**Minutes of the North Carolina Building Code Council**  
**April 21<sup>st</sup>, 2011**  
**Raleigh, NC**

**FIGURE R403.3 (1)  
CONCRETE AND MASONRY FOUNDATION DETAILS**

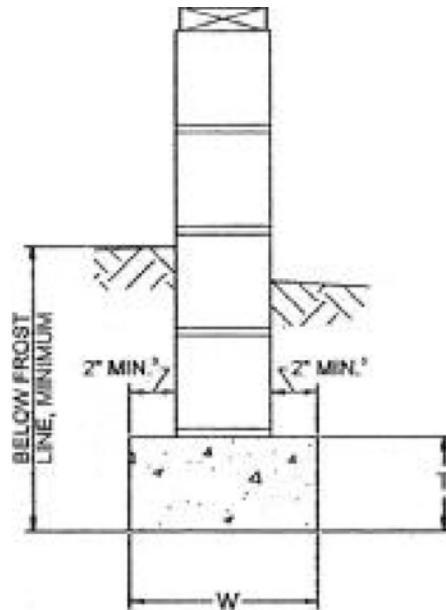
**Item – 20 Request by Robert Privott representing NC Home Builders Associations and Governor Beverly Perdue to amend the 2012 NC Residential Code, Table R403.3(1). The proposed amendment is as follows:**

1. Foundations shall extend not less than 12 inches below the natural grade or engineered fill finished grade and in no case less than the frost line depth.  
**REMAINING NOTES TO REMAIN THE SAME**

Motion/Second – David Smith/Adopted – The request was adopted. The effective date is January 1, 2012.
